OFFICE OF RIVER PROTECTION

19-TPD-0003

THE U.S. DEPARTMENT OF ENERGY, OFFICE OF RIVER PROTECTION RESPONSE
TO YOUR MAY 30, 2018 LETTER

Reference: Nez Perce letter from J. Bell to A. Smith, Ecology, and B.T. Vance, ORP, "Re: Data Quality Objective for Vadose Zone Characteristics at Waste Management Area A-AX, RPP-RPT-60227, Revision 0," dated May 30, 2018.

Figure 1. Top view of the proposed (recommended) slant push in the subsurface underneath tank A-105 and the meeting notes' vertical push Location #2 and slant push Location #3.

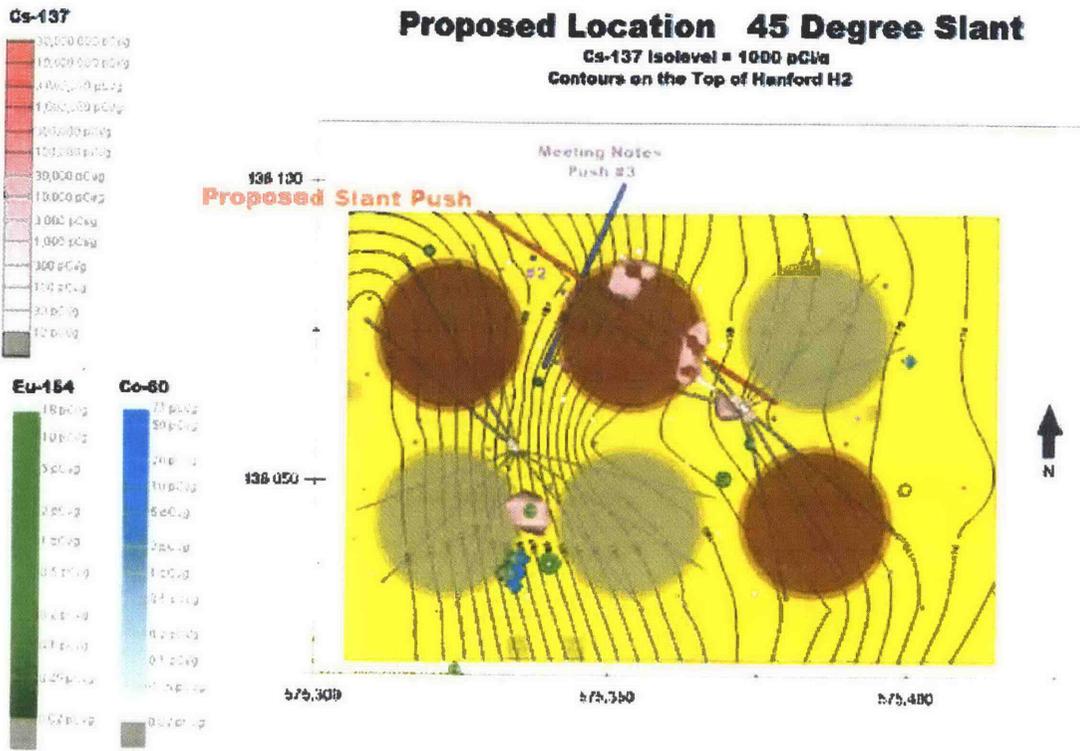
Instead of the meeting notes' pushes at Locations #2 and #3 (Figures 1, 2, and 3), I recommend a 45 degree slant push to the southeast that starts northwest of Tank A-105 and to the north of Tank A-104 (Figures 1, 2, and 3). This recommended slant push would evaluate the temperature anomaly encountered at C9383 and eliminate the need for location #2 as described in the meeting notes. The recommended slant push would evaluate the extent of Cs-137 in the Hanford H1 near the 14-05-02 lateral, which would aid in verifying the current A-105 tank leak estimate in RPP-ENV-37956, Rev. 2. This recommended slant push would evaluate the possibility of lateral migration of A-105 tank waste in the Hanford H2. None of the slant pushes indicated in the meeting notes are positioned to evaluate the potential for lateral migration of tank wastes from the A-105 tank leak. The recommended slant push eliminates the need for the slant push from Location #3 in the meeting notes by passing near the corrosion zone of corrosion observed in the 10-05-10 drywell. According to the meeting notes, one of the justifications for the push from Location #3 is to evaluate a "higher SGE conductivity area." At WMA C, higher SGE conductivity areas were identified under tanks C-101 and C-104. These "anomalies" were tested by slant push holes. None of the slant push holes detected significant contamination. Based on the experience at WMA C, it seems unreasonable to continue the use of SGE survey results to determine sample locations within tank farms.

We reviewed your recommendation for direct push locations (eliminating Locations 2 and 3 and including your proposed location). First, we need to identify that there are issues with your proposed location (subsurface infrastructure identified via ground penetrating radar [GPR] and retrieval project obstructions). There was much information, coordination, and discussion on the selected direct push locations and all the corresponding material was not included in the meeting notes (e.g., GPR and retrieval figures).

At this point, we are planning to move forward with the locations selected. We are targeting the silt zone in the Cold Creek Unit at approximately 285 ft bgs and want to maintain Location 2, the only vertical location, as it has the best chance of contacting the silt zone. Note that the longest pipe run for an angle push, to-date, is around 260 feet with a vertical depth of ~ 180 feet. These planned direct pushes have pipe runs greater than these lengths - up to 295 feet with vertical depths of 285 feet. Regarding Location 3, it was selected for more reasons than surface geophysical exploration (e.g., possible leak location area, higher drywell readings and corrosion).

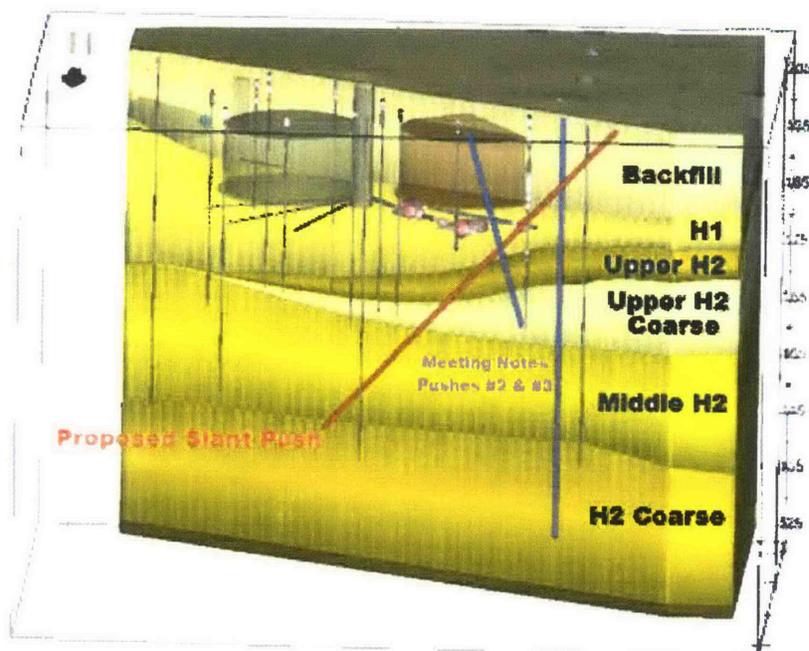
Figure 2. Visualization showing the location of the proposed (recommended) slant push in the subsurface underneath tank A-105 and its proximity to the vertical push at Location #2 in the meeting notes. The slant push from Location #3 in the meeting notes will be in the Upper H2 coarse unit when it is underneath the sidewall of tank A-105 and poorly

placed to evaluate the migration of contaminants from the A-105 tank leak if there is lateral migration of contaminants in the Upper H2.

Figure 1. Top view of the proposed (recommended) slant push in the subsurface underneath tank A-105 and the meeting notes' vertical push Location #2 and slant push Location #3.

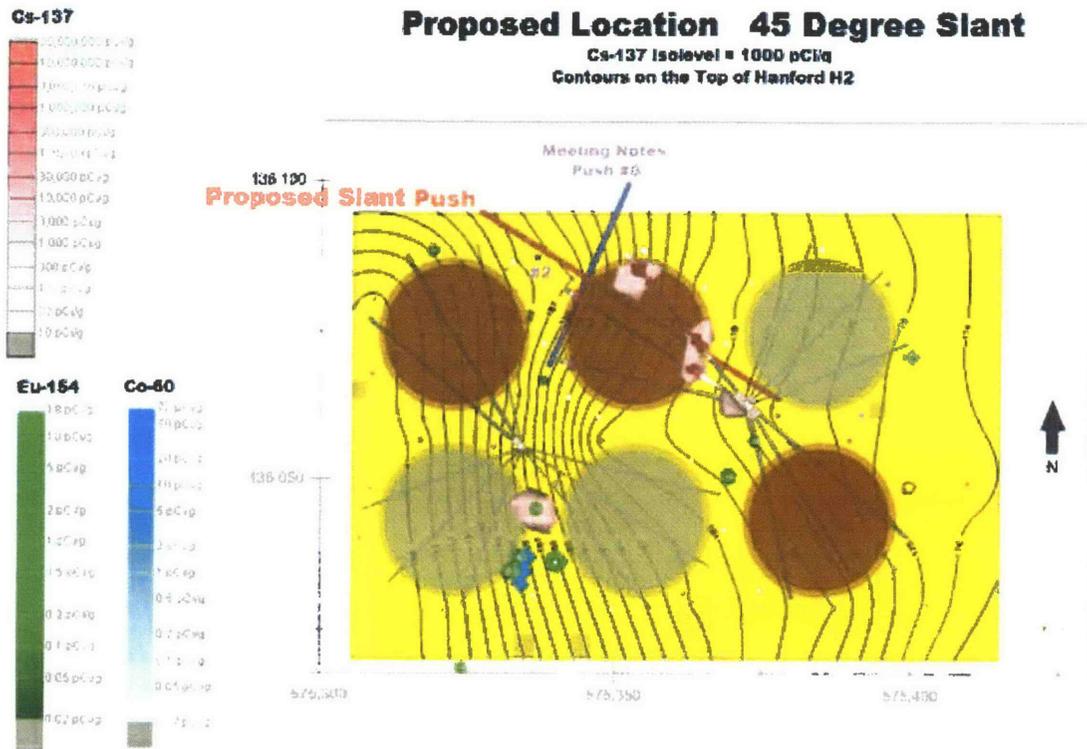
Instead of the meeting notes' pushes at Locations #2 and #3 (Figures 1, 2, and 3), I recommend a 45 degree slant push to the southeast that starts northwest of Tank A-105 and to the north of Tank A-104 (Figures 1, 2, and 3). This recommended slant push would evaluate the temperature anomaly encountered at C9383 and eliminate the need for location #2 as described in the meeting notes. The recommended slant push would evaluate the extent of Cs-137 in the Hanford H1 near the 14-05-02 lateral, which would aid in verifying the current A-105 tank leak estimate in RPP-ENV-37956, Rev. 2. This recommended slant push would evaluate the possibility of lateral migration of A-105 tank waste in the Hanford H2. None of the slant pushes indicated in the meeting notes are positioned to evaluate the potential for lateral migration of tank wastes from the A-105 tank leak. The recommended slant push eliminates the need for the slant push from Location #3 in the meeting notes by passing near the corrosion zone of corrosion observed in the 10-05-10 drywell. According to the meeting notes, one of the justifications for the push from Location #3 is to evaluate a "higher SGE conductivity area." At WMA C, higher SGE conductivity areas were identified under tanks C-101 and C-104. These "anomalies" were tested by slant push holes. None of the slant push holes detected significant contamination. Based on the experience at WMA C, it seems unreasonable to continue the use of SGE survey results to determine sample locations within tank farms.

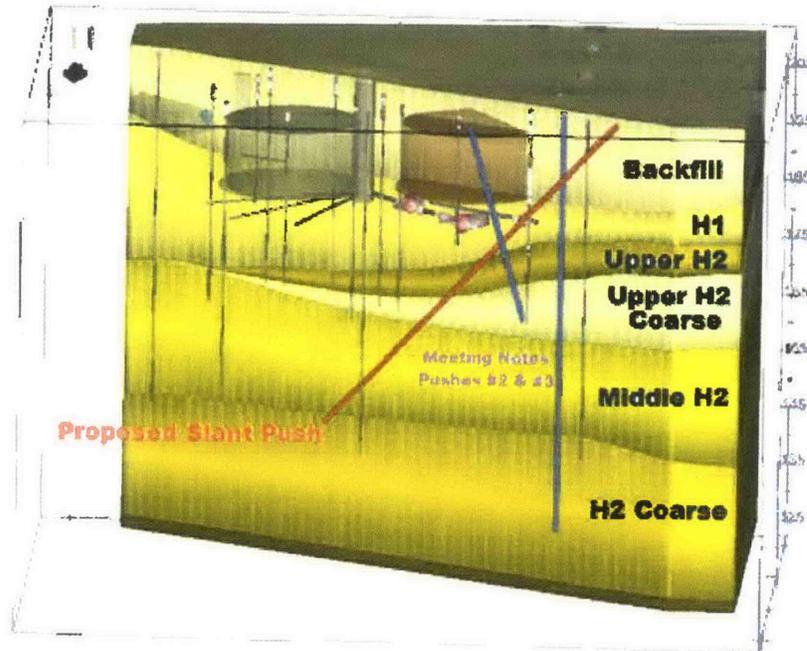
Figure 2. Visualization showing the location of the proposed (recommended) slant push in the subsurface underneath tank A-105 and its proximity to the vertical push at Location #2 in the meeting notes. The slant push from Location #3 in the meeting notes will be in the Upper H2 coarse unit when it is underneath the sidewall of tank A-105 and poorly

placed to evaluate the migration of contaminants from the A-105 tank leak if there is lateral migration of contaminants in the Upper H2.
